## ON-SITE SEWAGE DISPOSAL SYSTEM HOWARD COUNTY HEALTH DEPARTMENT BUREAU OF ENVIRONMENTAL HEALTH

ADDRESS: 3310 Brantly Road PROPERTY OWNER: Lon Meier

SITE INSPECTION SHEET

REVISED SEPTIC AREA

LOCATION DIAGRAM

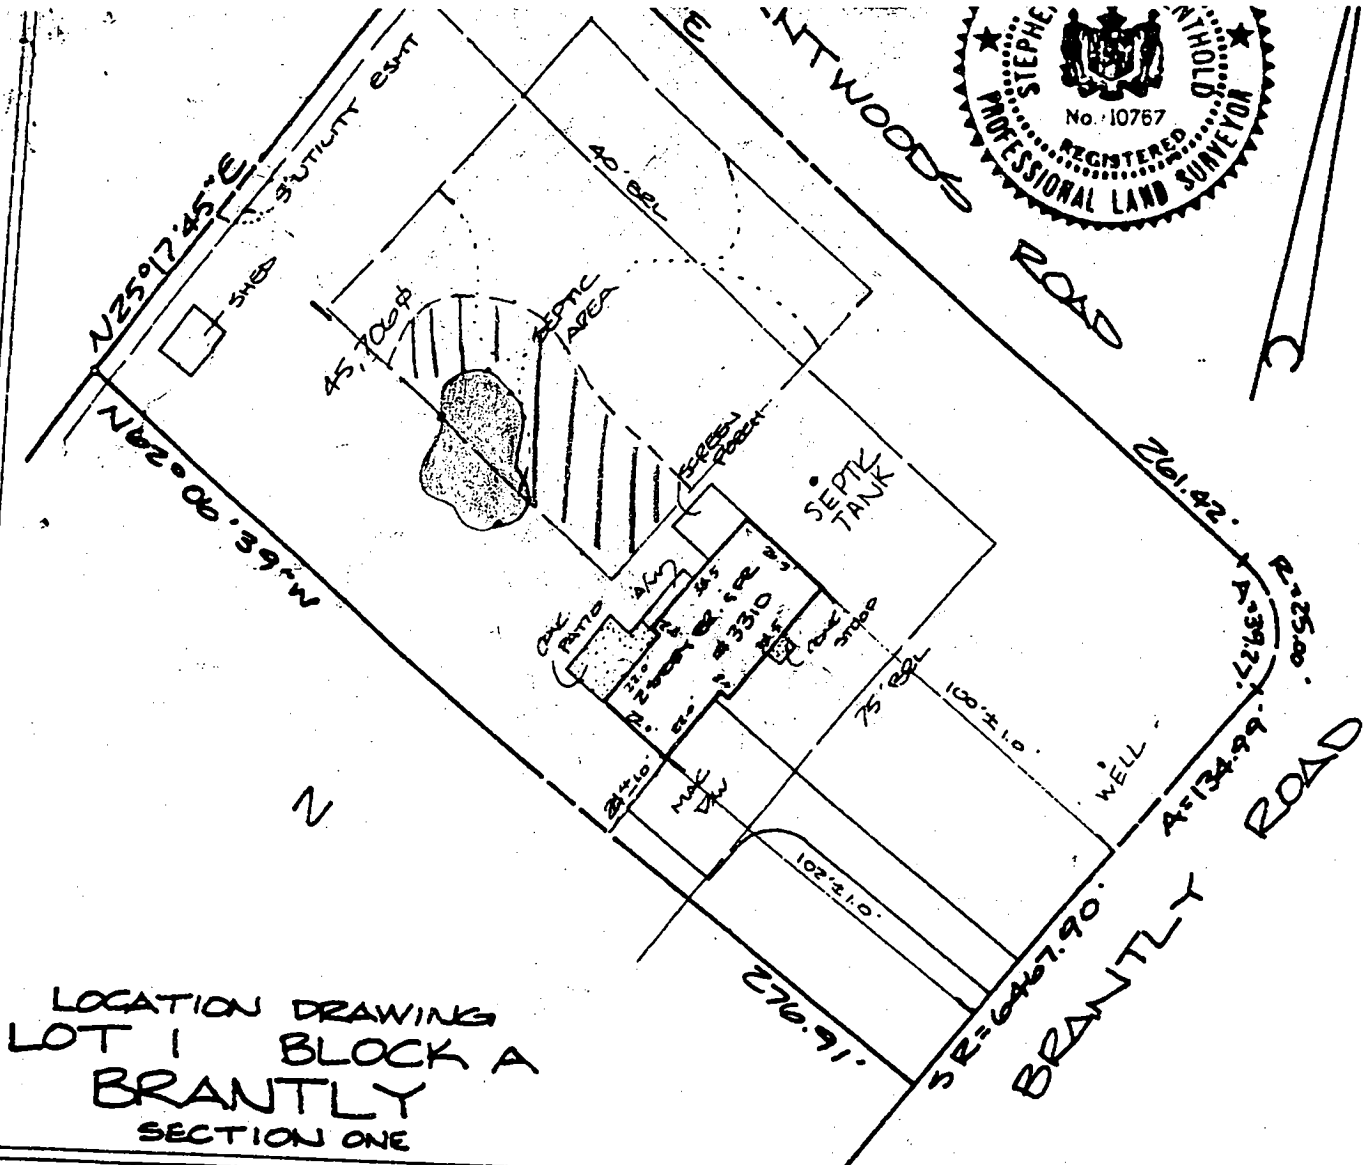
COMMENTS: - Proposed pool location is OK.  
Soils look good and they have plenty of room in the back yard. - Well tag # doesn't match well completion Report -

LOCATION DRAWING  
 LOT 1 BLOCK A  
 BRANTLY  
 SECTION ONE

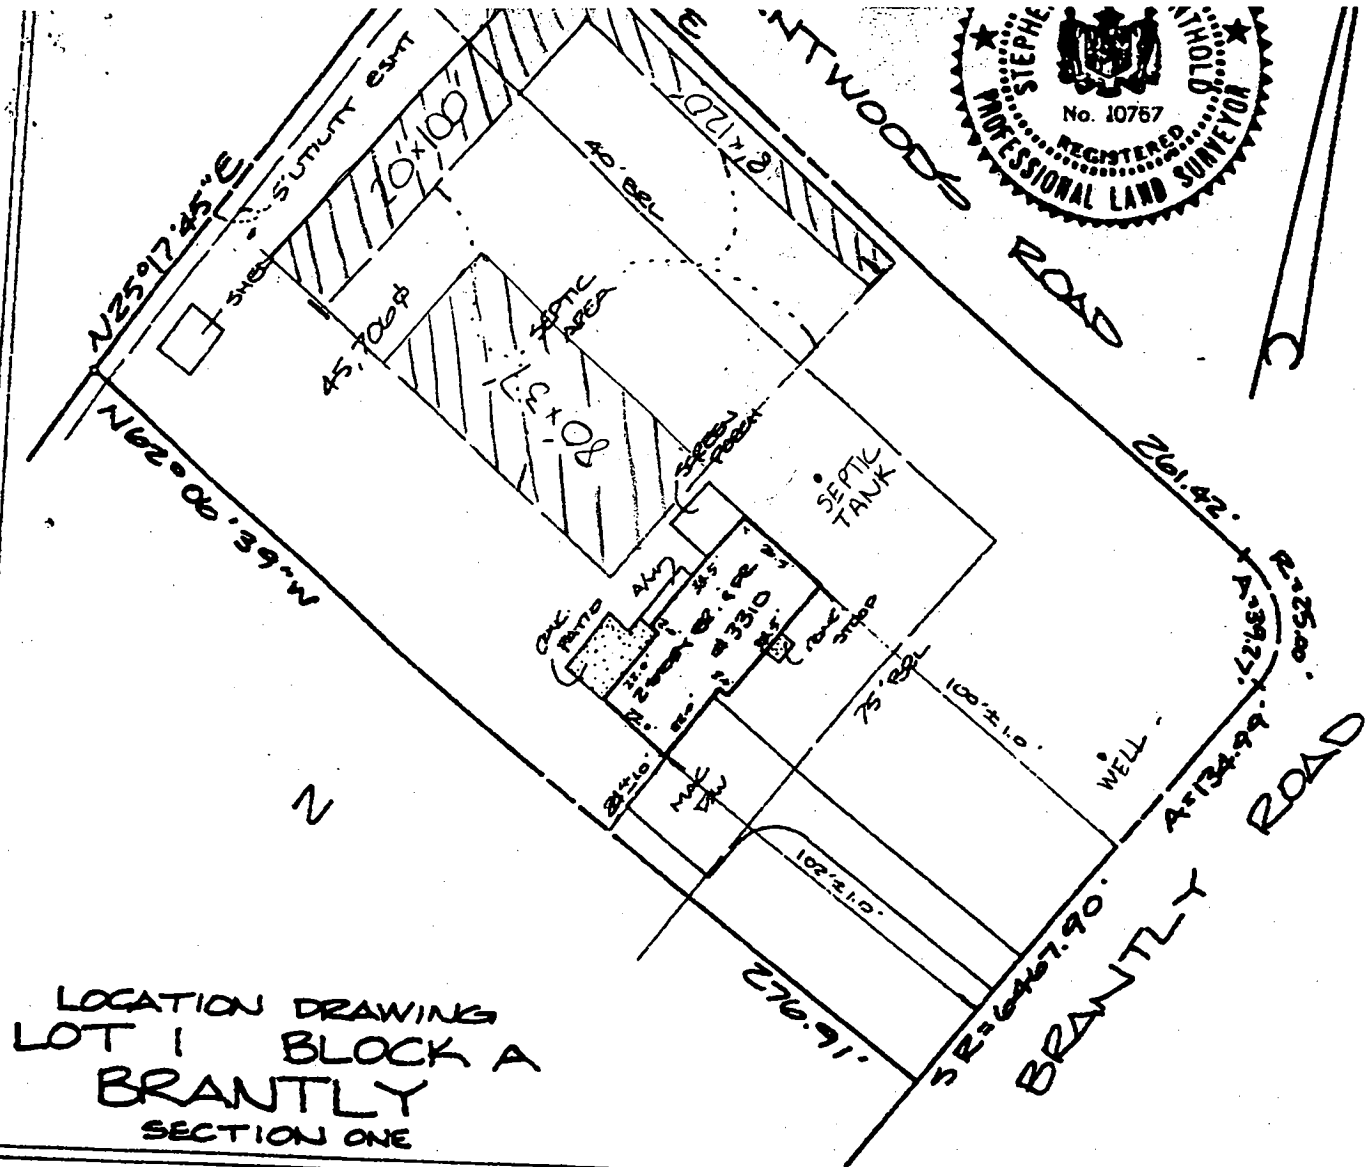
Proposed swimming pool  
 and buffer area   
 Reserve area to be moved 80ft x 37ft = 2960 sq ft

LOCATION DRAWING  
 LOT 1 BLOCK A  
 BRANTLY  
 SECTION ONE

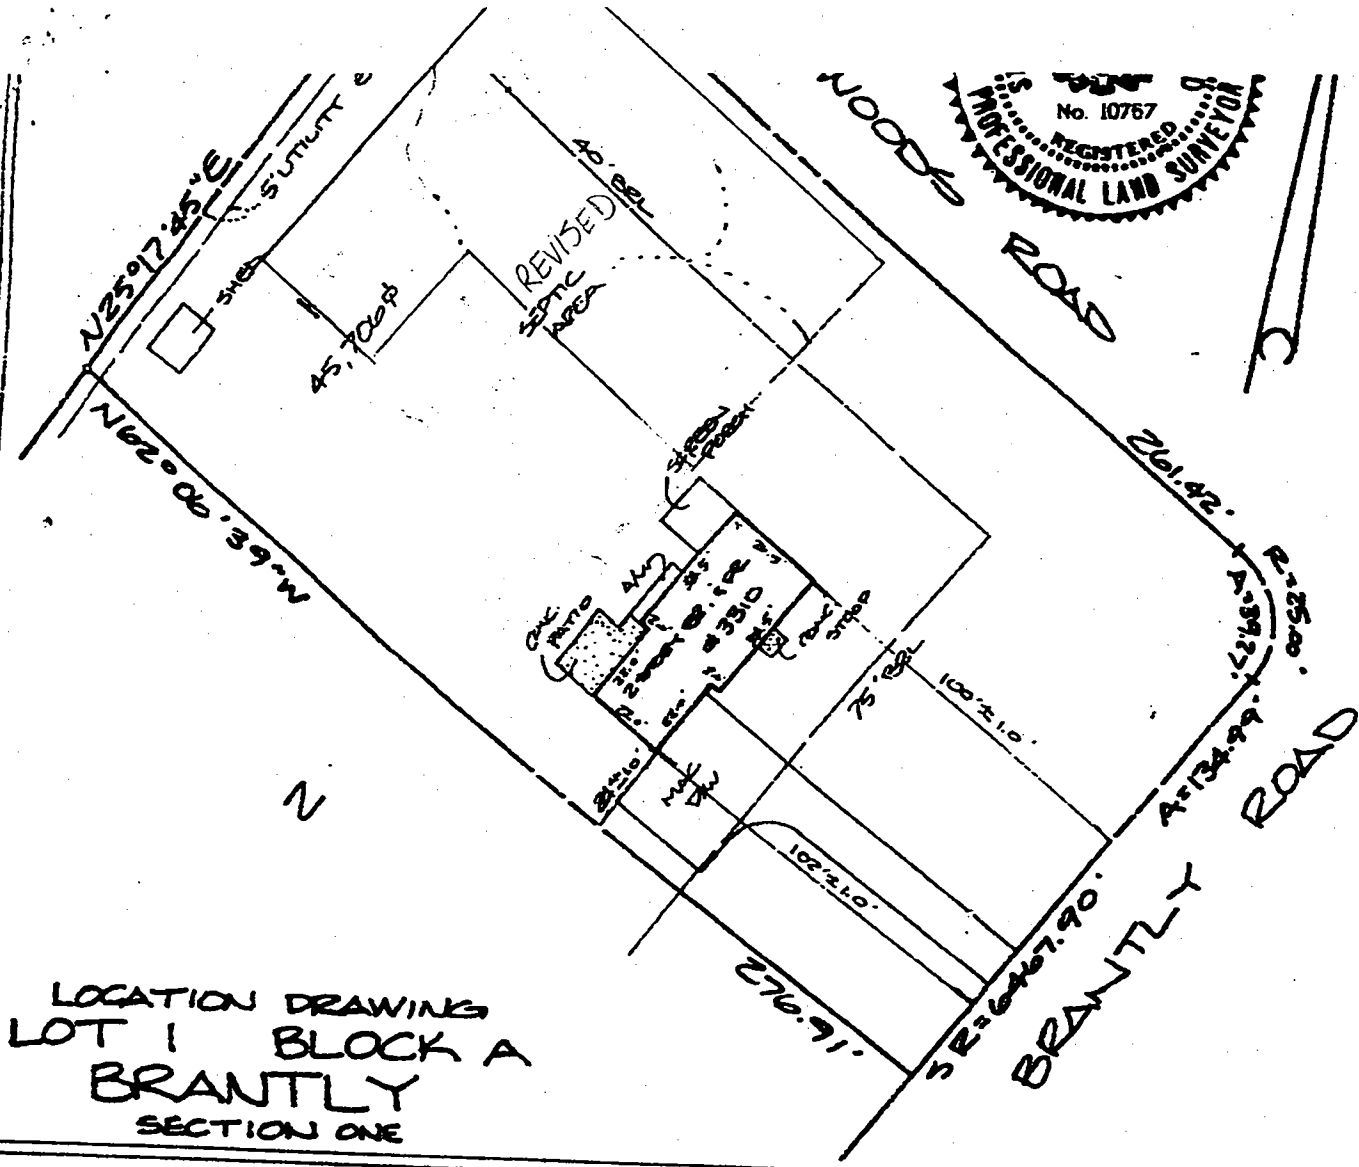
////// = SEPTIC AREA TO BE RELOCATED  
 $80' \times 37' = 2960 \text{ sq ft}$   
 //// = Relocated Septic Area  
 $20' \times 100' = 2000 \text{ sq ft}$   
 $8' \times 170' = 960 \text{ sq ft} = 2960 \text{ sq ft}$
